AGENDA
CHASKA PLANNING COMMISSION
CHASKA CITY HALL - COUNCIL CHAMBERS & ZOOM
Wednesday, December 11, 2024
7:00 PM

REQUEST FOR ACTION
CHASKA PLANNING COMMISSION
12/11/2024

Subject: **Beckman Coulter – 316 Lake Hazeltine Drive – Concept Plan**

To: **Planning Commission**
From: **Matt Clark, City Engineer**
Date: **December 6, 2024**
Subject: **316 Lake Hazeltine Drive Concept Plan – Engineering Review**

SITE PLAN

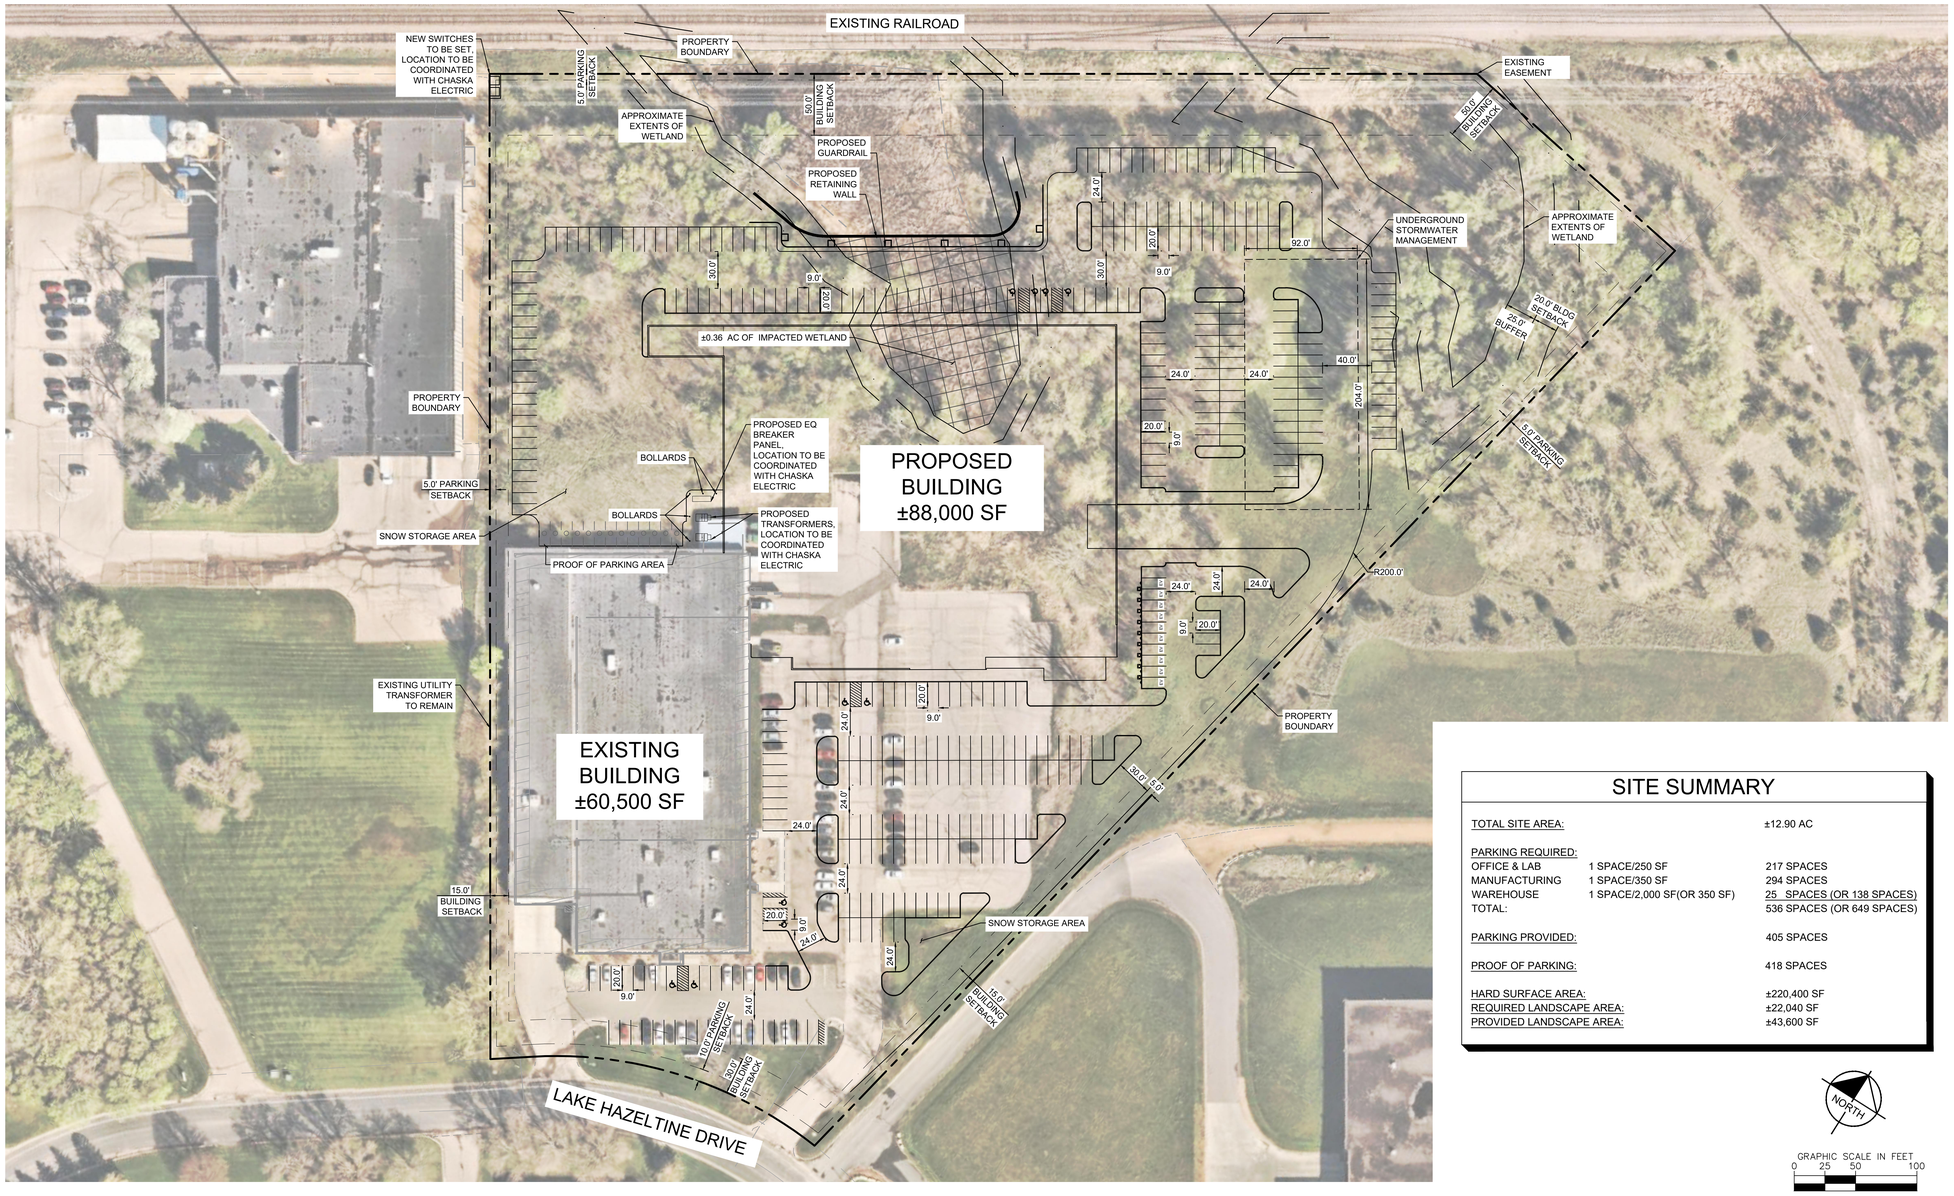
According to the table above the applicant is insufficient in meeting parking for the site based on the existing and proposed uses. The applicant will have to show how they meet this requirement in the preliminary and explain the parking need of the facility.

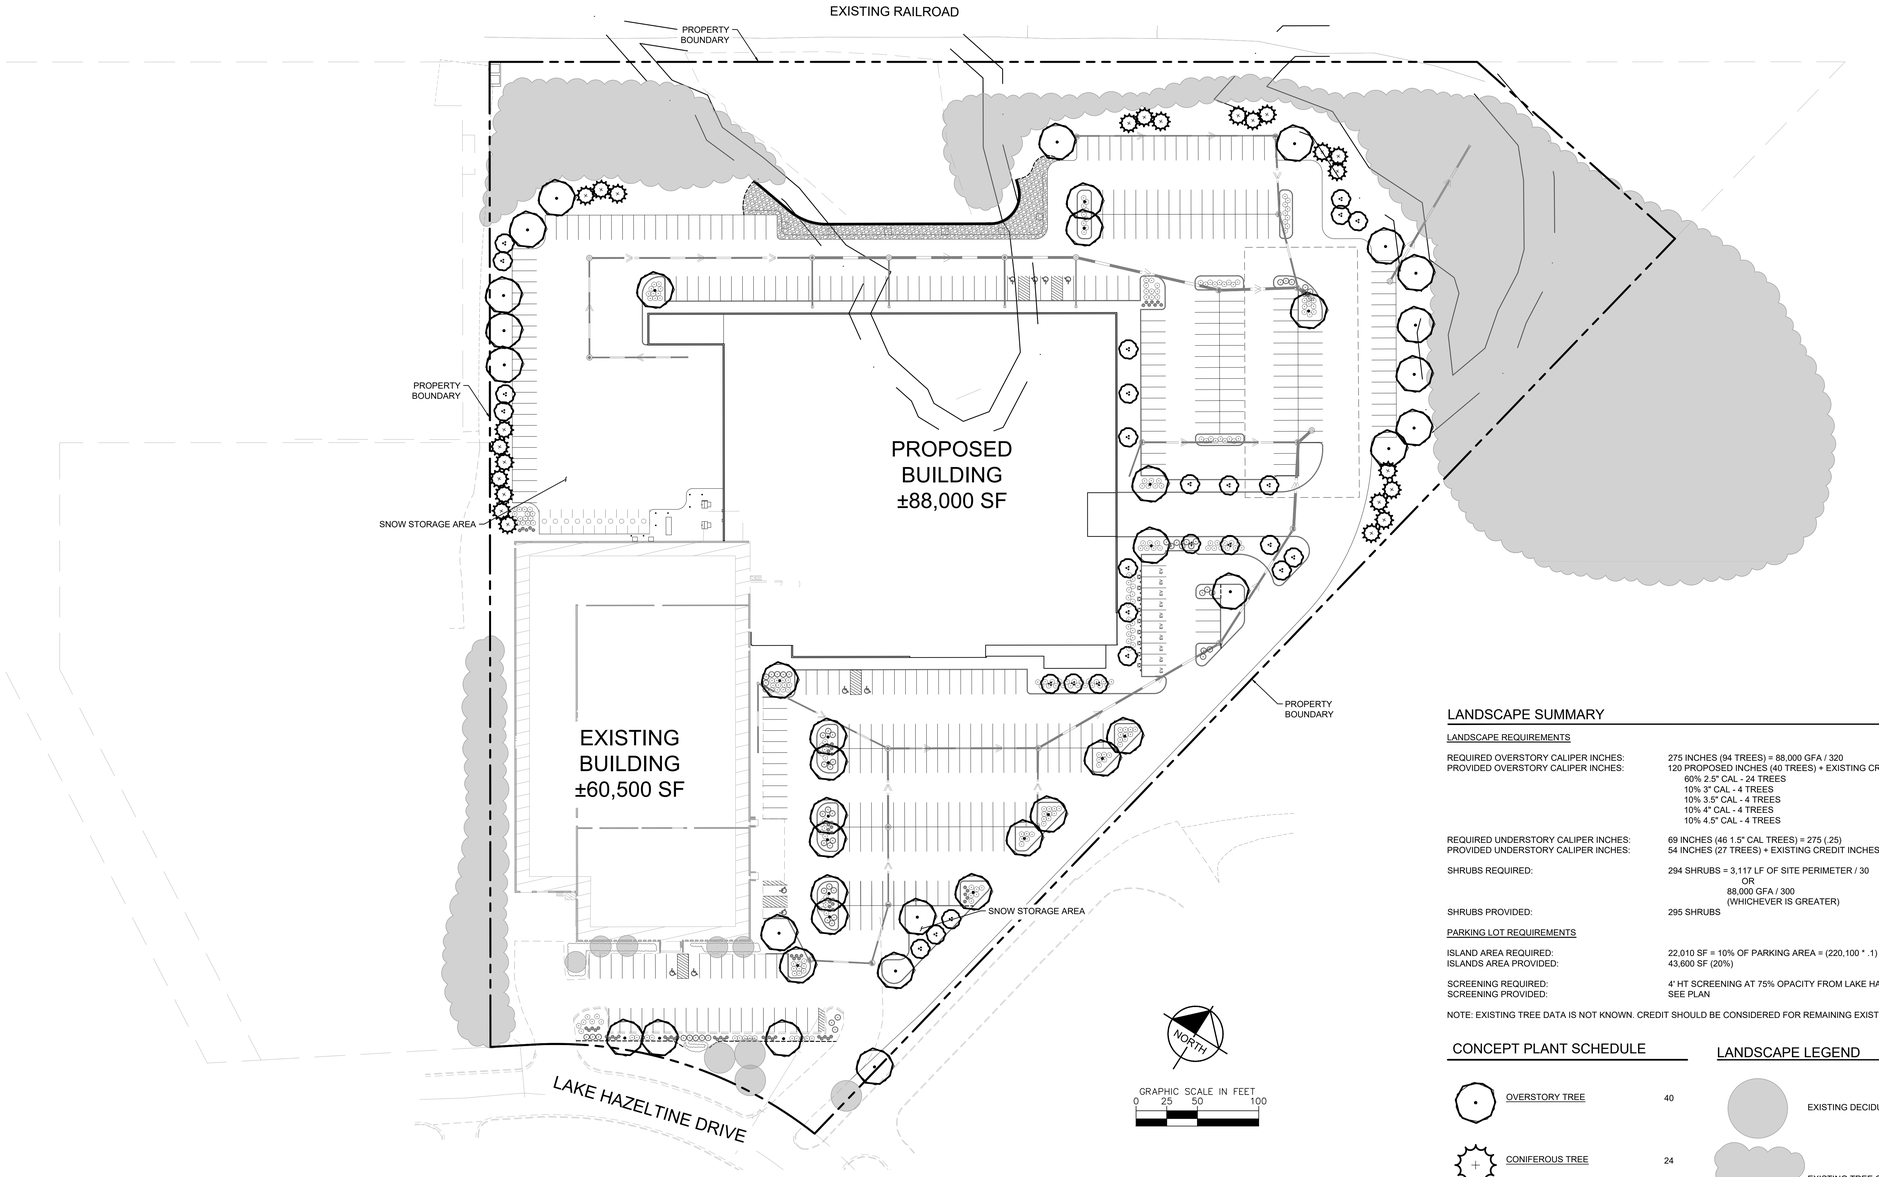
The applicant will have to show in their preliminary submittal how they meet the landscape ordinance (Section 15.28.070), including but not limited to planting island requirements.
